## CLEVELAND NATIONAL FOREST POWER LINE REPLACEMENT PROJECTS

### MINOR PROJECT REFINEMENT REQUEST FORM

<b>Date Submitted:</b>	09-12-19	<b>Request #:</b>	40
<b>Date Approval Required:</b>	09-26-19	<b>Landowner:</b>	Not Applicable (N/A)
<b>APN:</b>	N/A, occurs within road right-of-way		
<b>Refinement from (check all that apply):</b>			
<input type="checkbox"/> Mitigation Measure	<input type="checkbox"/> APM	<input checked="" type="checkbox"/> Project Description	<input type="checkbox"/> Drawing <input checked="" type="checkbox"/> Other
<b>Identify source (mitigation measure, project description, etc.):</b>			
<p>Notice to Proceed (NTP) request #10 for Phase I Underground of Circuit (C) 440 of the San Diego Gas &amp; Electric Company (SDG&amp;E) Cleveland National Forest Power Line Replacement Projects (Project) was approved by the California Public Utilities Commission (CPUC) and United States Forest Service (USFS) on October 27, 2017. NTP request #23 for Phase I Overhead of C440 of the Project was approved by the USFS on June 28, 2019 and by the CPUC on July 11, 2019. Following the issuance of NTP #10, a refinement (additional underground alignment) to NTP #10 was identified due t

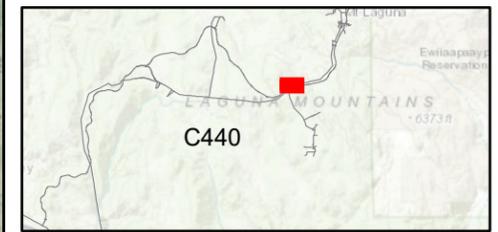
<b>(d) Does the proposed refinement trigger an additional permit requirement?</b>				<input type="checkbox"/> Yes	<input checked="" type="checkbox"/> No
<b>Describe refinement being requested (attach drawings and photos as needed):</b>					
As depicted in Attachment B: Comparison Map, SDG&E is requesting to add approximately 44 feet of underground alignment between Vault 121 <sup>1</sup> and Pole P258301 along Sunrise Highway, as well as the associated temporary underground work limits. The requested refinement will result in a total of approximately 0.01 acre of temporary impacts (of which less than 0.01 acre is classified as native vegetation). <sup>2</sup> The activities associated with the construction and utilization of the refinement area will occur in the same manner as described in the Final EIR/EIS for construction of the Project.					
<b>Provide need for refinement (attach drawings and photos as needed):</b>

The requested refinement is needed due to engineering changes made to the final design for Phase I of C440 between the issuance of NTPs #10 and #23. Following the issuance of NTP #10, Pole P258301, which was approved in NTP #23, was converted from being fed by Pole P259843 to being fed via a new underground alignment from Vault 121. Therefore, the requested refinement is required to complete the final underground design for NTP #10.					
<b>Date refinement is expected to be implemented:</b>				09-27-19	
<b>Resource Agency Coordination</b>					
<b>Resource Agency</b>	<b>Name</b>	<b>Action Required</b>	<b>Date</b>	<b>Documentation (see attached if yes)</b>	
N/A	N/A	N/A	N/A	<input type="checkbox"/> Yes	<input checked="" type="checkbox"/> No
